Re: Percolation Certification Plat Review  
Regan Property  
3866 Ivory Road

Re: Regan Property  
3866 Ivory Road  
DDC project number 05028.1

Re: Regan Property – Percolation Certification Plat  
3866 Ivory Road  
Glenelg, MD 21737  
DDC Project No. 05028.1

REGAN PROPERTY  
PERCOLATION CERTIFICATION PLAN

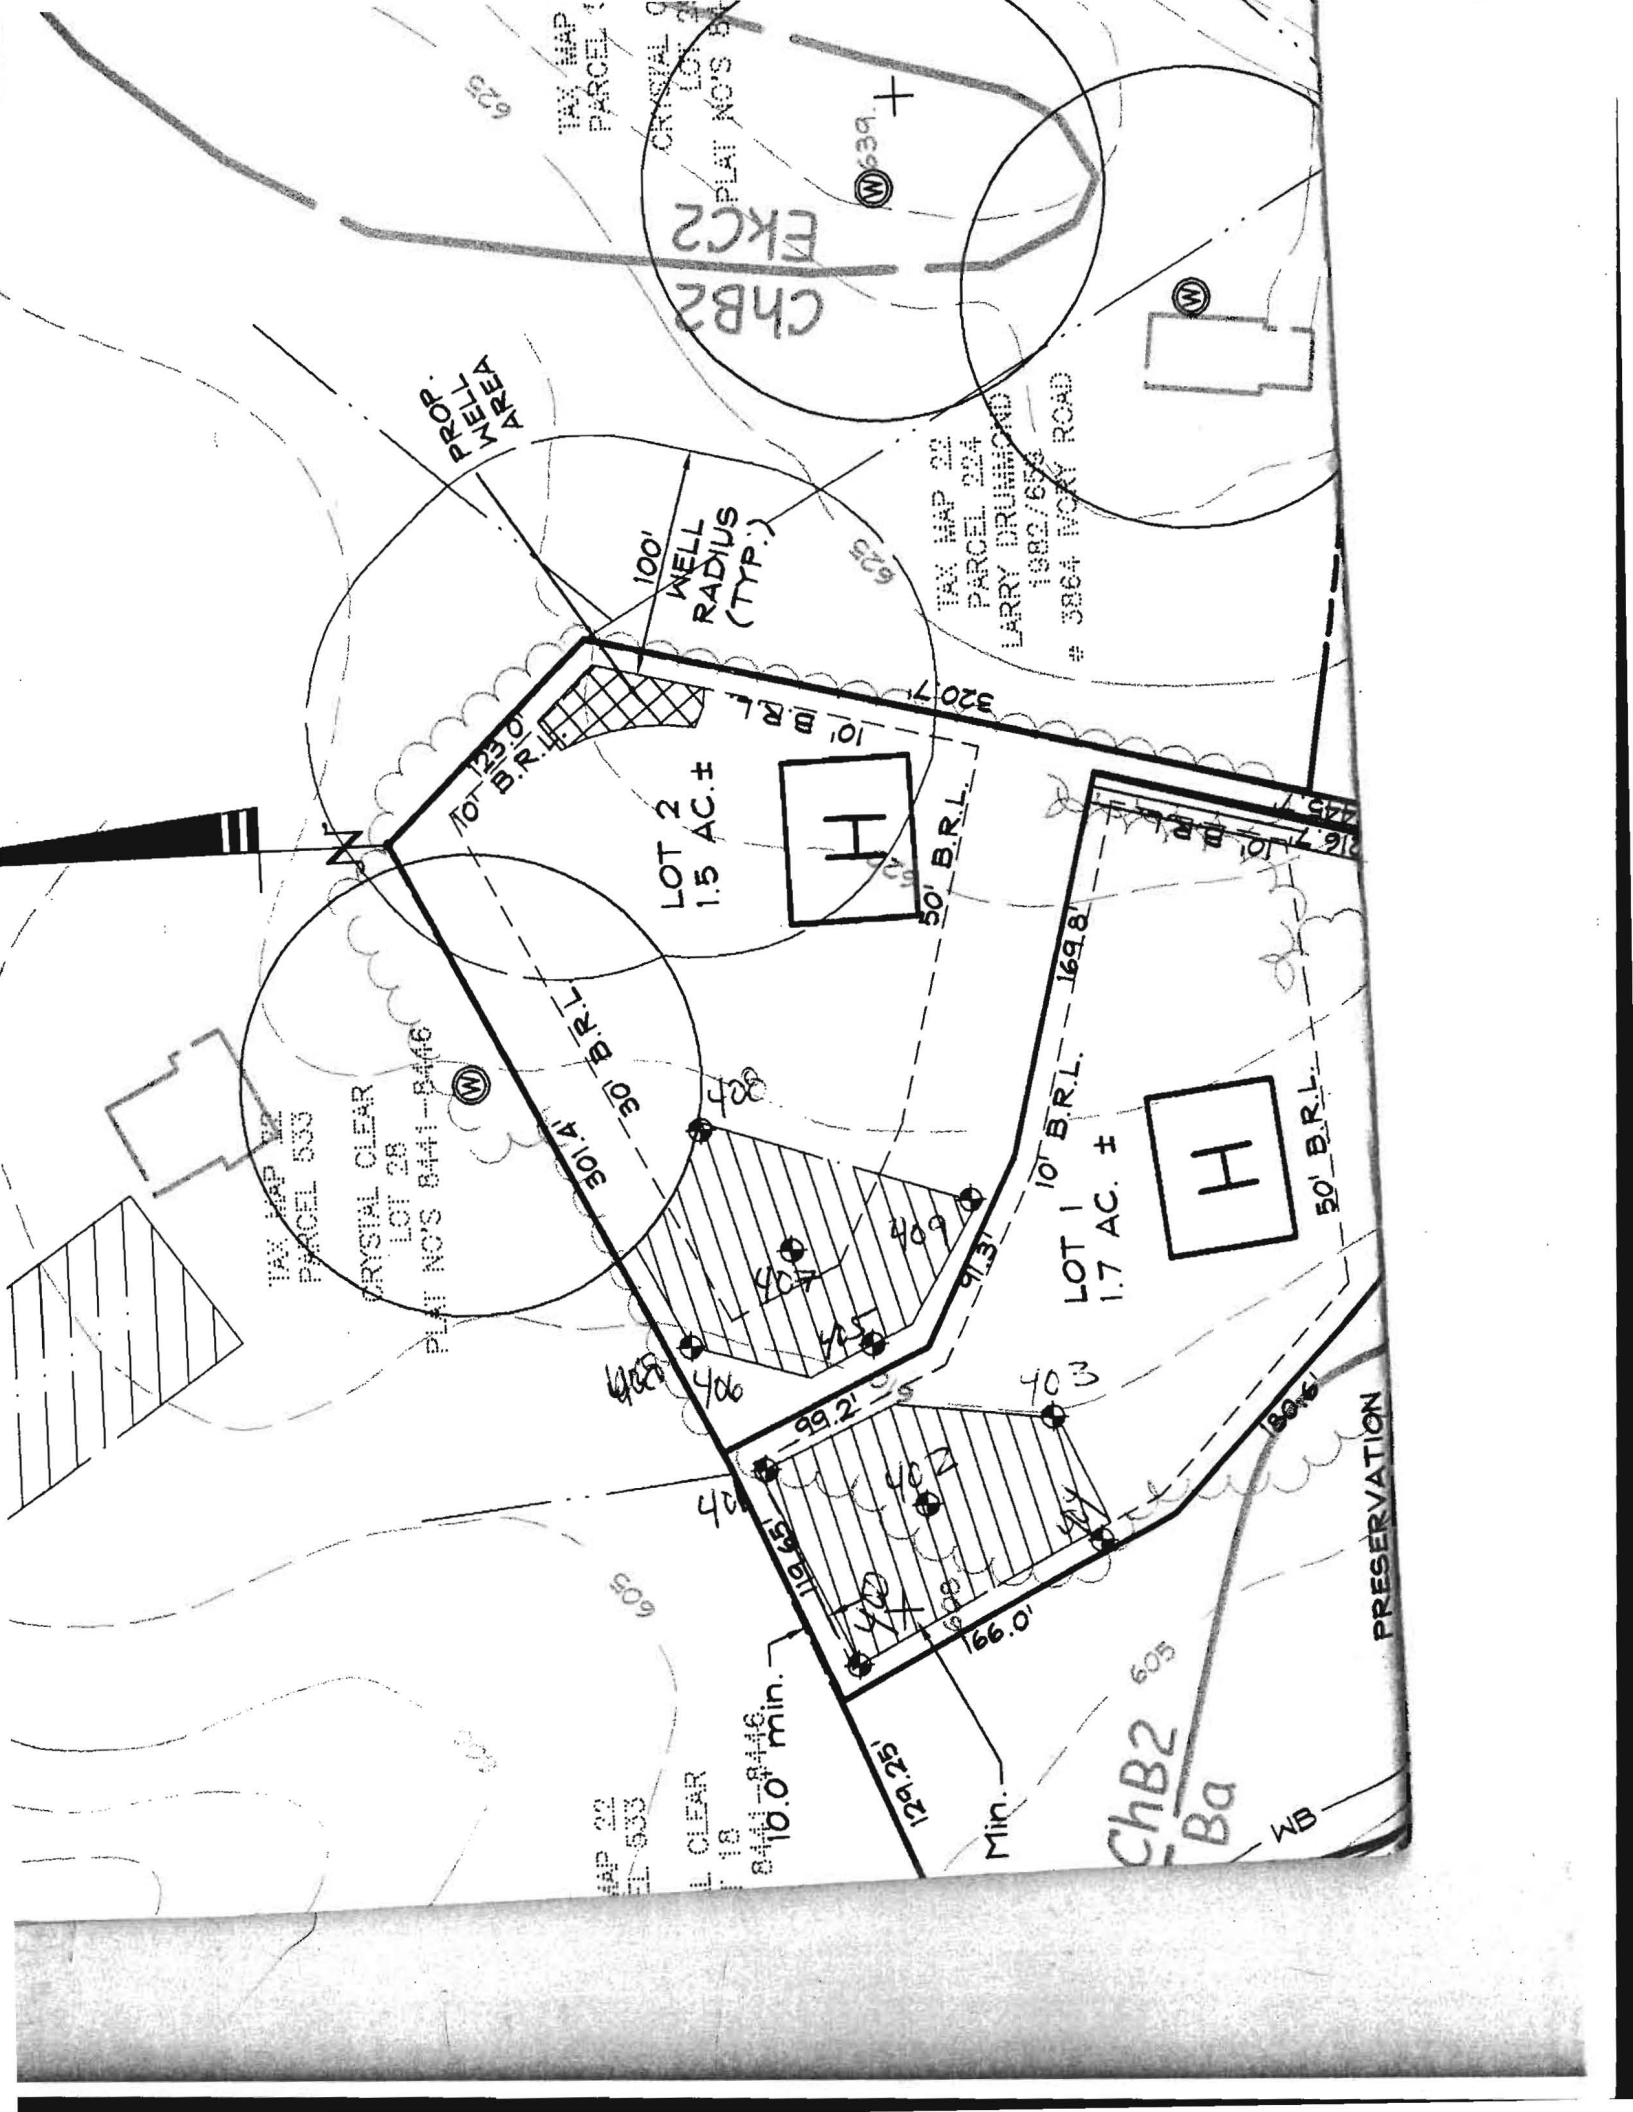
We submitted the perc certification plan for approval and received a comment letter from Ms. Noonan indicating that the two Preservation Parcels must be "connected" in order to utilize the third replacement area for the existing house. This is not possible due to site constraints and perc test locations.

We would like to request permission to locate the third replacement area for the existing house on Non-Buildable Preservation Parcel A, while the first two are located on Preservation Parcel B. The two Parcels will remain under the same ownership, and an easement will be provided across the panhandles for future construction of the third septic system.

We would very much appreciate your consideration of this matter, and approval of the percolation certification plan as it is presently shown. We will address the other comments included in the comment letter dated May 12, 2006 when we have assurance from your office that the plan is approvable with the third replacement area located on Non-Buildable Preservation Parcel A.

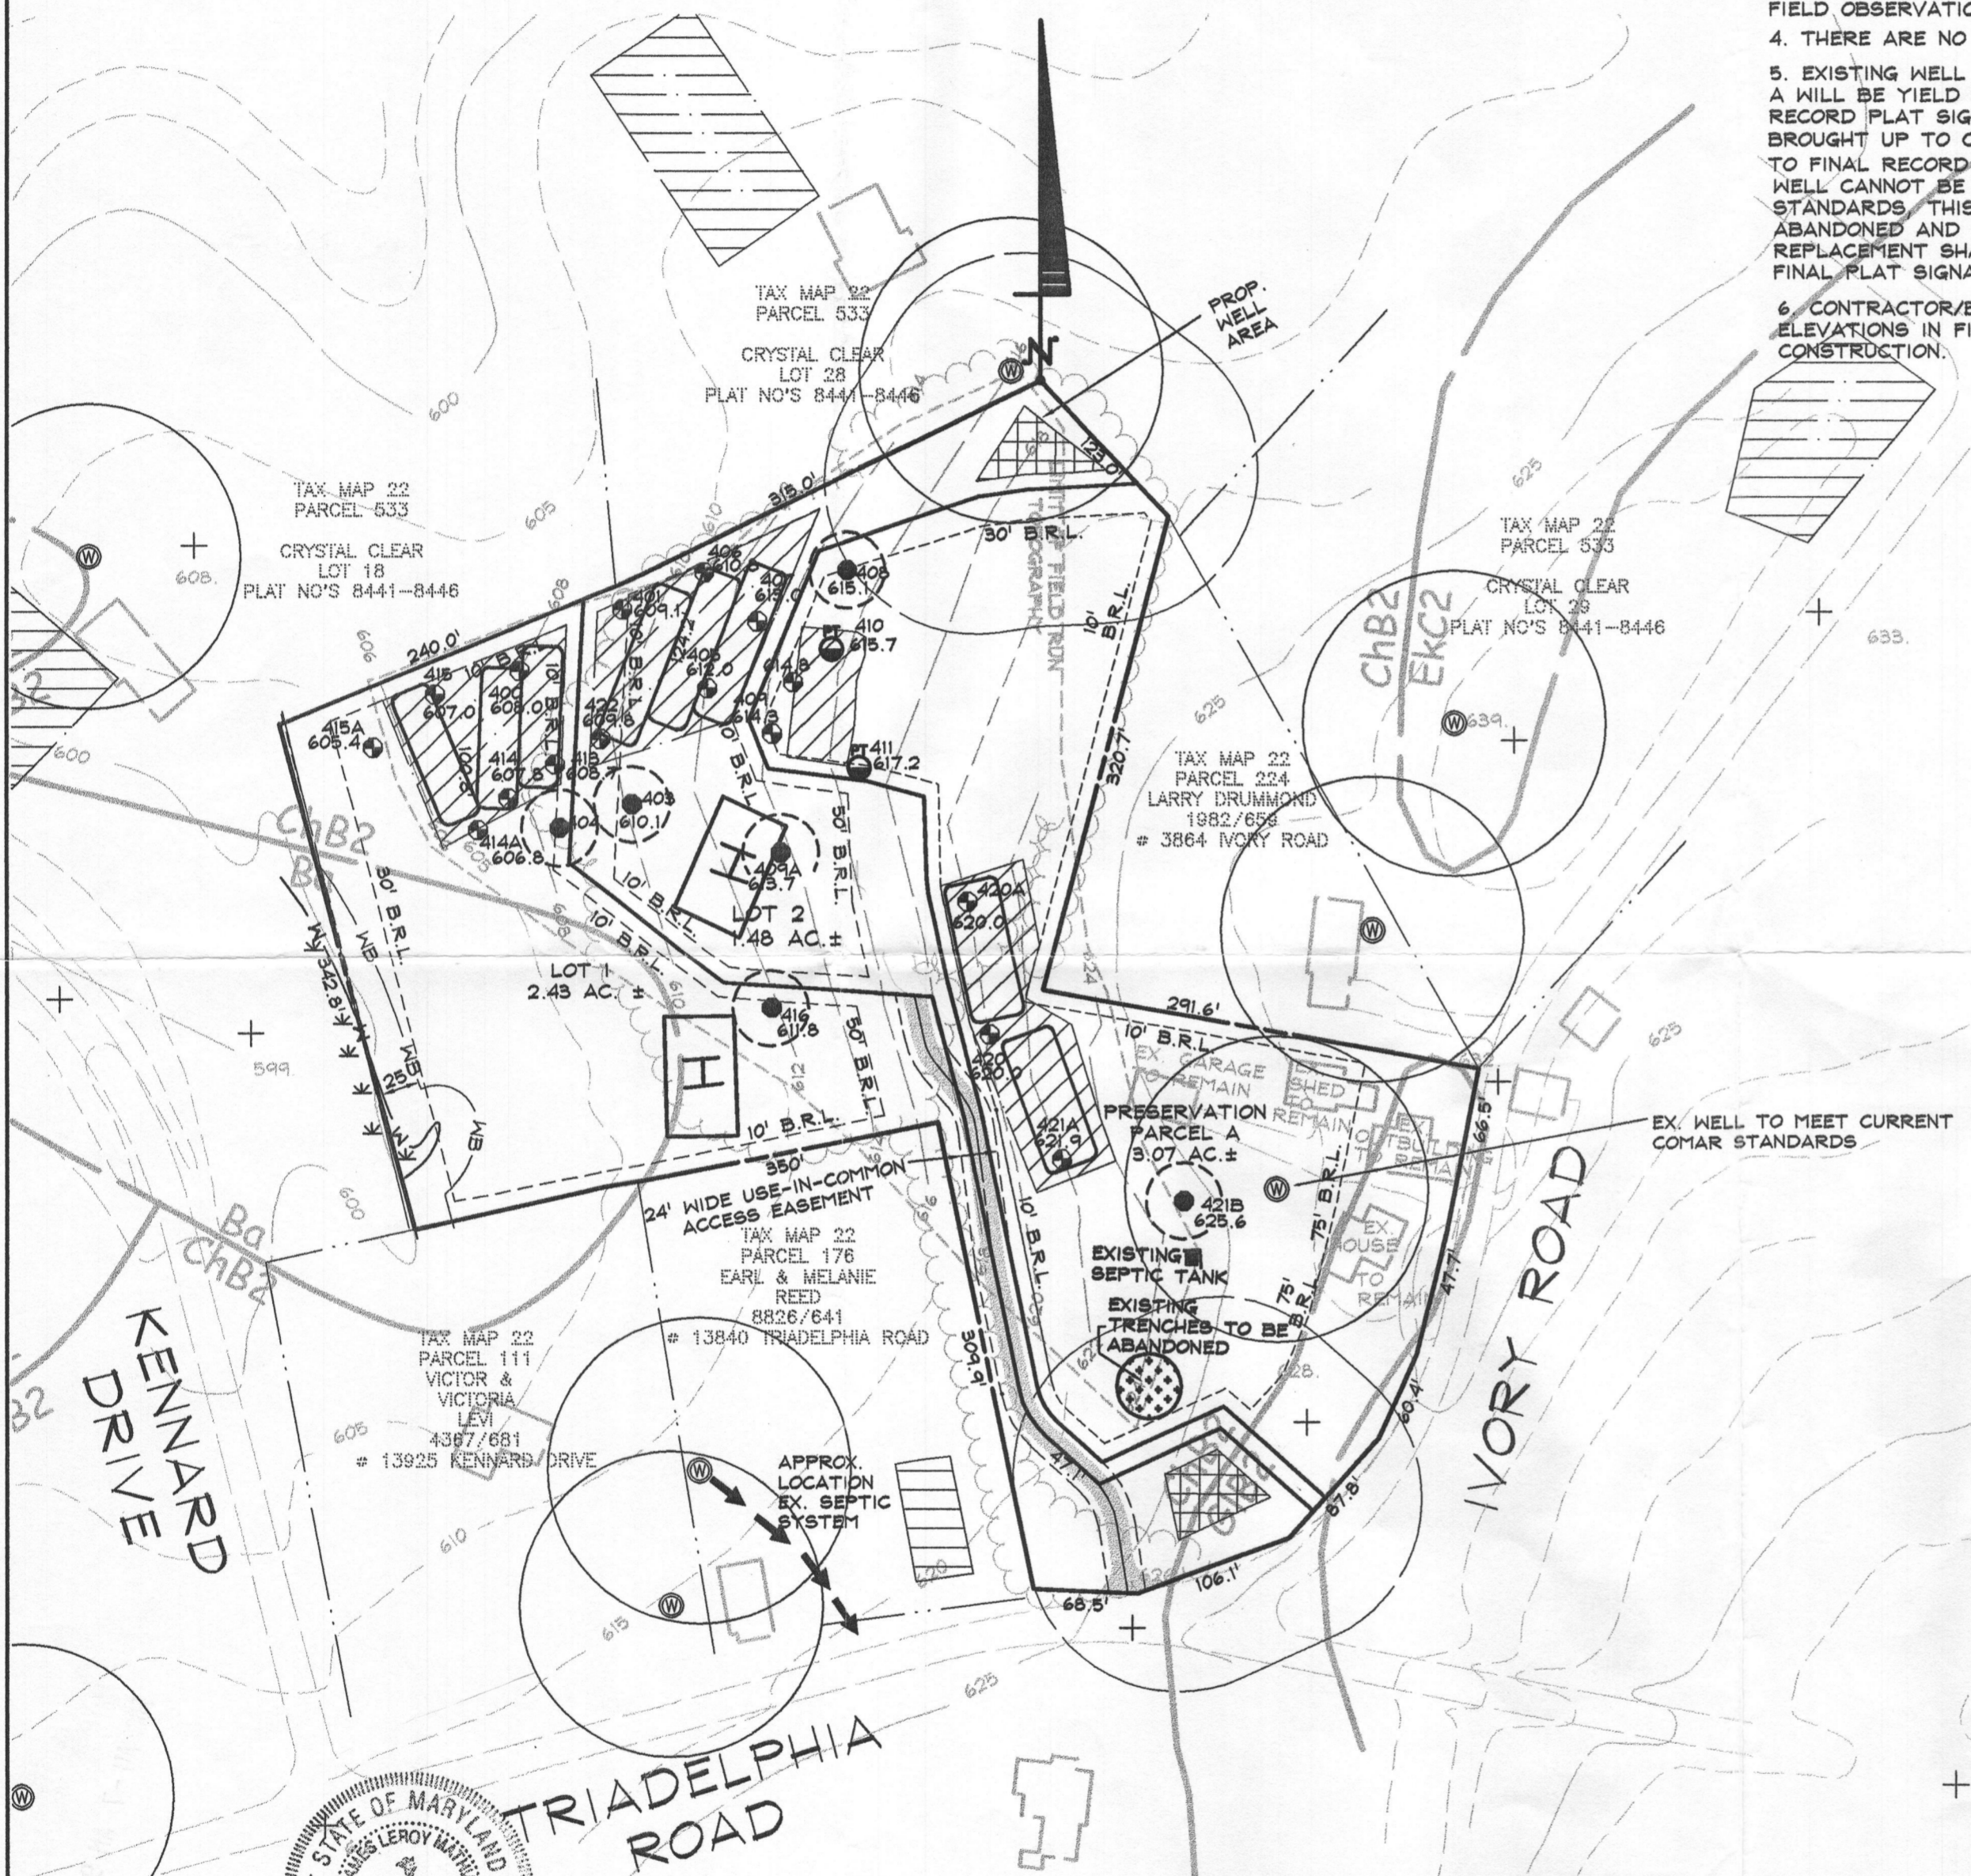
- A general note stating that all wells shall be drilled prior to health department signature of the final recordation plat is not included. (see enclosed)
- Three existing structures on Preservation Parcel A. have not been labeled nor has their intent been stated.
- Include a general note statement regarding the existing well. The Howard County Health Department will require that this well be brought up to current standards prior to final record plat signature. If the well cannot be brought up to current standards, this well shall be abandoned and sealed and a replacement shall be drilled (prior to final plat signature).
- Ensure that the well radius for lot 1 is not encroaching on the septic system or approved repair area on Parcel 176. Failure to locate these areas accurately could result in rejection of the percolation certificate plat.

**Response: This note has been added to the plan as requested (see general note no. 11).**

**Response: The existing structures have been labeled and their intent stated.**

**Response: We have added this information to general note number 5.**

**Response: The well area and well radius for Lot 1 have been adjusted so that the well radius is not encroaching onto any part of Parcel 176, therefore it does**

**not encroach on the septic system or any approved repair area for that Parcel.**
